Addendum/Addenda

1

Project Description / Description de projet Sanitary and Storm Sewer Separation – Phase 3 Montreal Road Campus		
Solicitation No./ N° de sollicitation 18-22005	Project No./N° de projet 5097-3	W.O. No./N° d'ordre de travail
Departmental Representative / Représentant Ministériel Doug Sanftenberg	Date May 28,2018	
Notice: This addendum shall form part of the tender documents and all conditions shall apply and be read in conjunction with the original plans and specifications.		Nota: Cet addenda fait partie intégrale des dossiers d'appel d'offres; toutes les conditions énoncées doivent être lues et appliquées en conjonction avec les plans et les devis originaux.

DWG. No.: W29

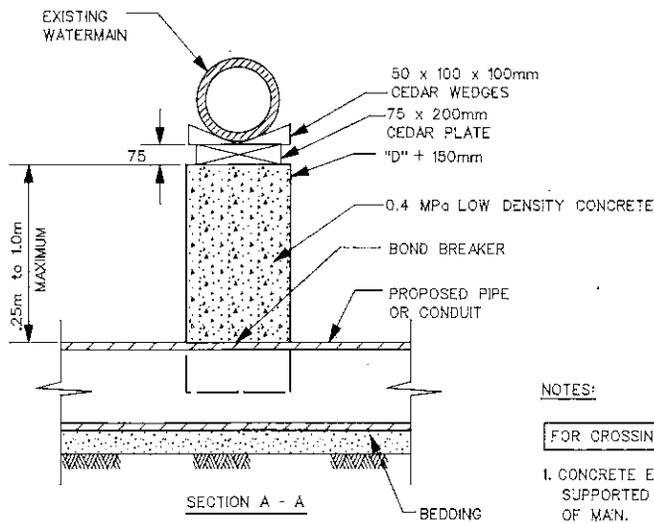
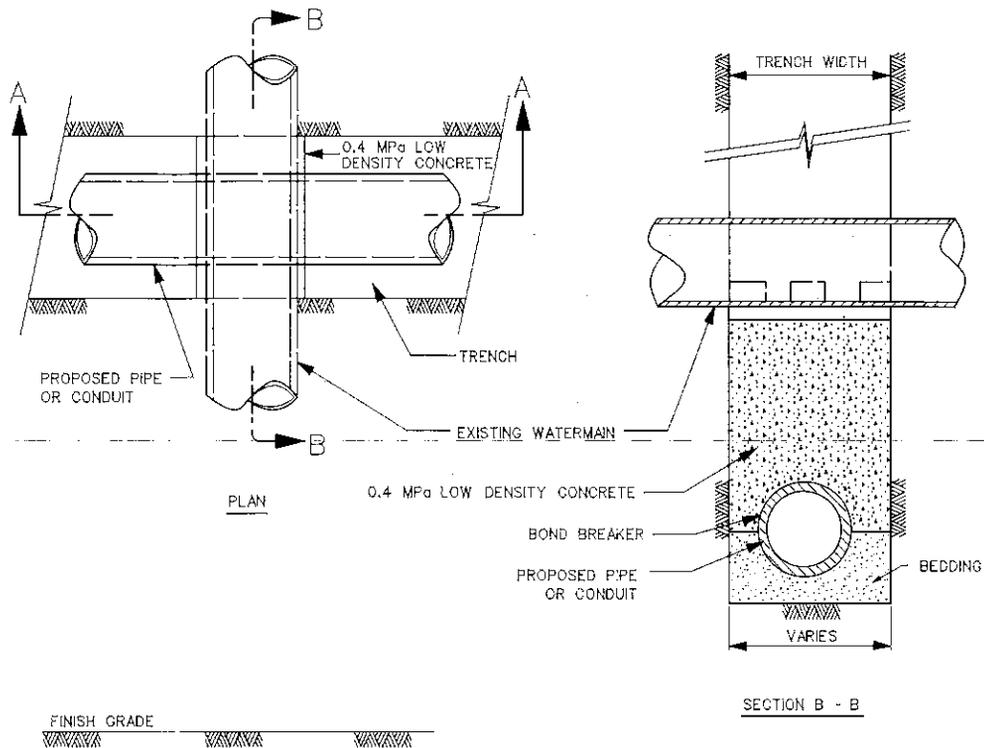
On drawing 5097-C302-2, note 8.2 shall read:

“The Contractor shall determine the exact invert (geodetic elevation), diameter and construction material of the existing conduits at the proposed connections **and crossings**. The Contractor shall carry out, if necessary, all exploratory excavations required to determine the exact location and inverts of existing underground infrastructure. The exploratory information shall immediately be provided to the Departmental Representative prior to undertaking any municipal services work and a 48 hour period must be allocated to the Departmental Representative for design review. **At crossings with existing utilities (hydro, gas, watermain, sewers, etc.), the Contractor must provide temporary support of the existing utilities as per detail 337 (shown on drawing 5097-C308-1), and complete the work as per City of Ottawa standard details W29 and W29.1.**”
